This gallery shows some pictures of bad solderings - they should prevent you from making the same errors (feel free to add even more pictures here!)

<http://wiki.midibox.org/> - **MIDIbox**

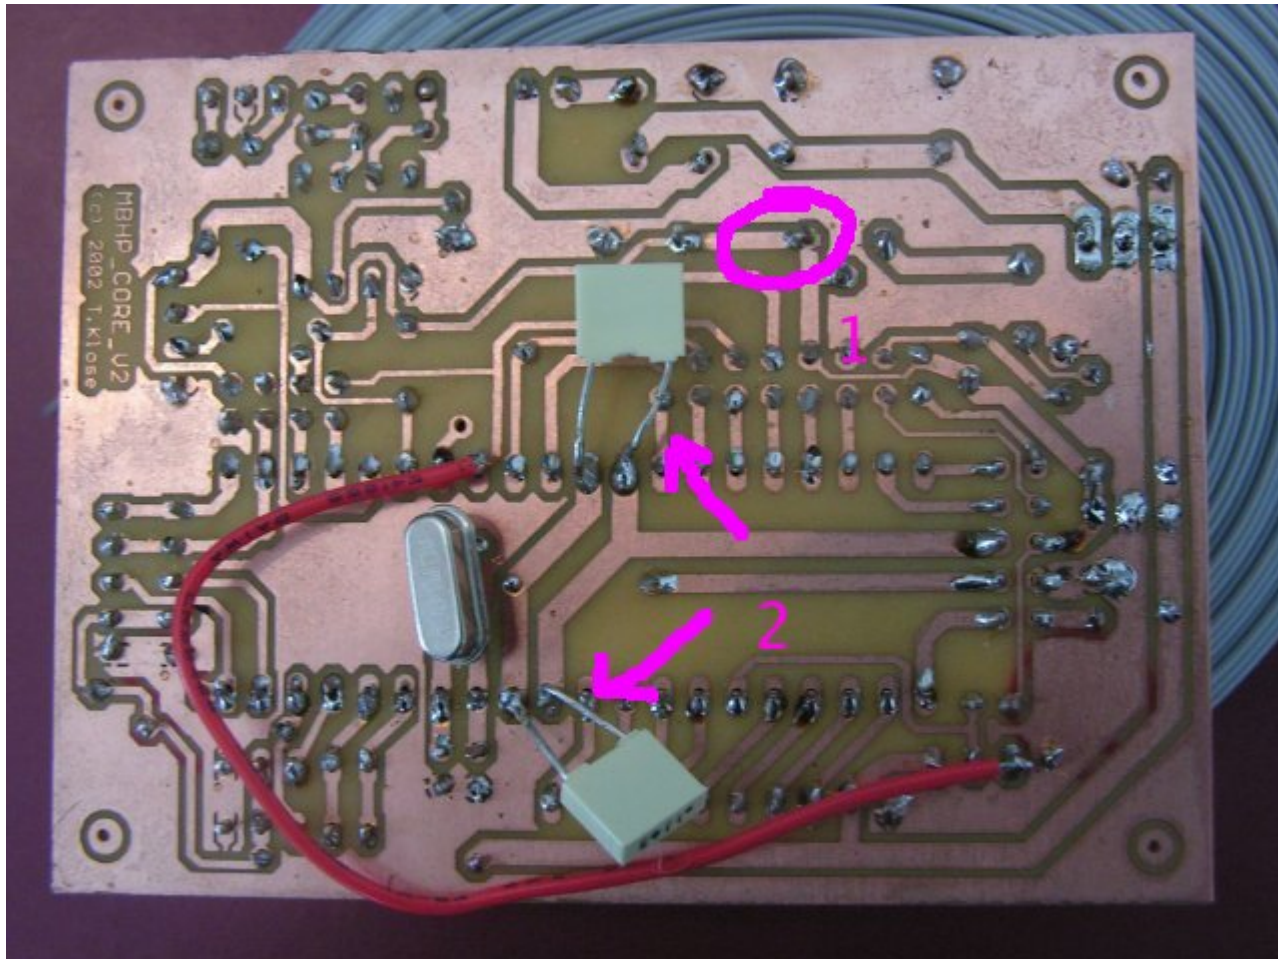
1: the core module has some bad solderings (loose connections), which could lead to failures. There are also missing solderings (e.g. 33pF cap below crystal). It makes sense to solder each pad again, the [Soldering](#) guide in the Wiki gives some useful tips

2: the legs of the caps should be cutted, otherwise they can cause a short circuit which can damage the PIC!

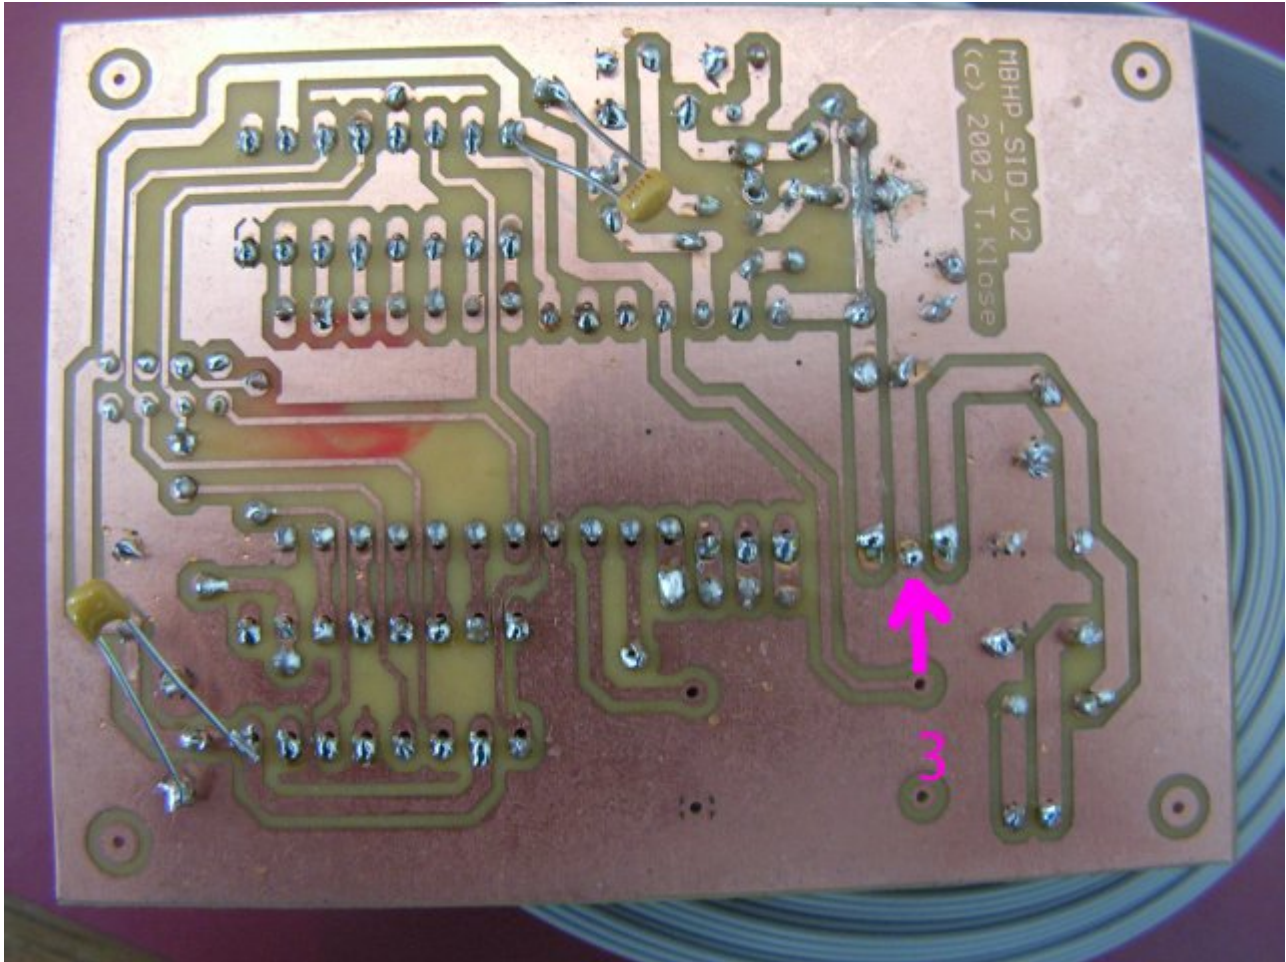
3: this seems to be a bad ground connection directly at the 78xx - it can lead to the wrong voltage. Here the same: just solder the pads again, it will help  
And same like above: the long cap legs need to be cutted, the danger for shorts is too high!
